COMMONWEALTH OF KENTUCKY  
BEFORE THE PUBLIC SERVICE COMMISSION

APPLICATION OF SOUTHERN MADISON	)	
WATER DISTRICT FOR CERTIFICATE OF	)	
CONVENIENCE AND NECESSITY TO COMPLETE	)	CASE NO. 92-161
CONSTRUCTION OF STORAGE FACILITIES	)

INVESTIGATION OF THE HYDRAULIC CAPABILITY OF THE  
SOUTHERN MADISON WATER DISTRICT  
CASE NO. 92-161

January 29, 1993

Figure No. 1

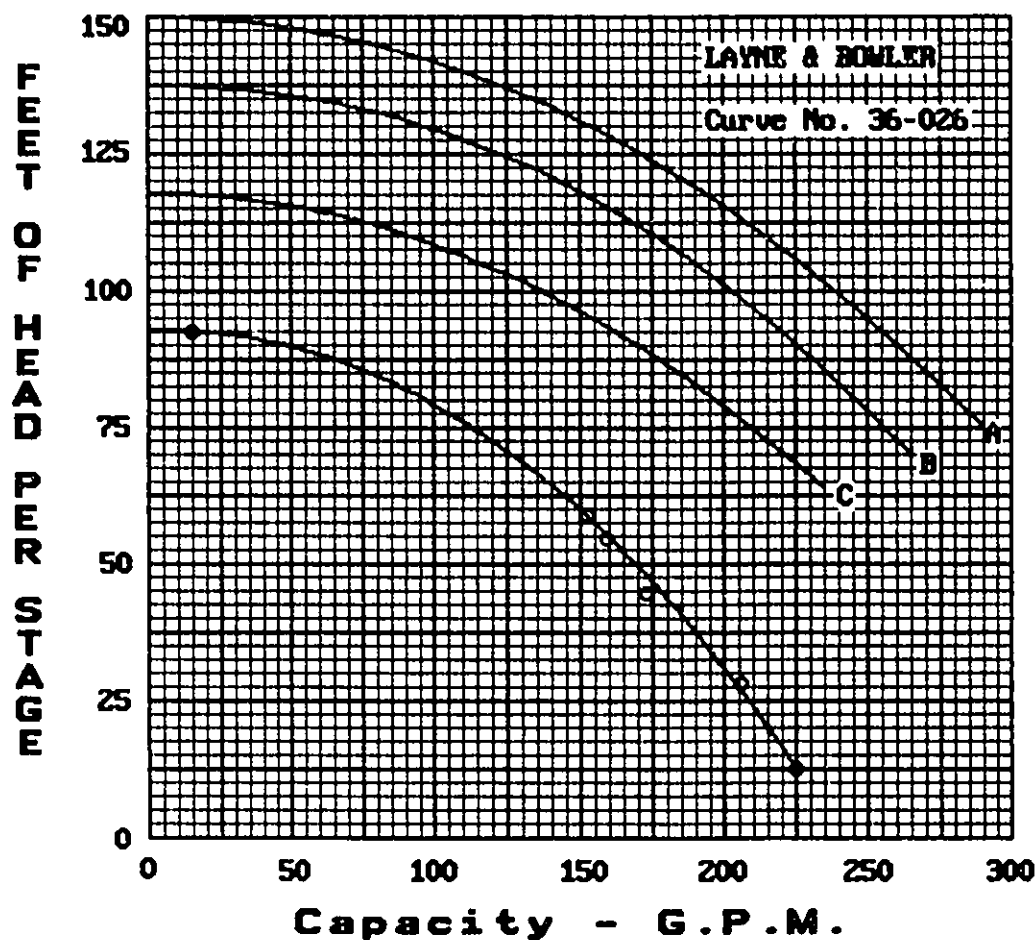
During the Commission's engineering staff's review of Southern Madison's construction proposal in Case No. 90-305 a copy of the manufacturer's pump curve was obtained from the pump station manufacturer (copy attached). The pump operation data contained in Table IV was reduced to pump flow VS head per stage for each of the

observed points and plotted on a pump capacity graph. A computer program was written to calculate and draw a pump characteristic curve to fit the plotted points using the pump formula used in Dr. Wood's KYPIPE program. The curve as constructed is subject to some error, of course, due to the limited range of operation points and the lack of precise measurements. Nevertheless, the curve is a useful indication of the capability of the District's I-75 pump station. In addition to the constructed curve the three characteristic curves "A", "B", and "C" from Layne & Bowler Curve No. 36-026 were also computer drawn on the head VS capacity graph for comparison. This graph is shown on following page as Figure No. 1.

The pump curve calculated from the field test data and shown in Figure No. 1 was substituted for the two pumps at Southern Madison's I-75 pump station. Pump No. 1 was entered as a two-stage pump and Pump No. 2 was entered as a three-stage pump. The constrained pipe feature of KYPIPE2 was utilized to calculate a minor loss component for the partially closed valve in the pump station by-pass pipeline. This feature was used to match the three different valve settings used on October 21, 1992.
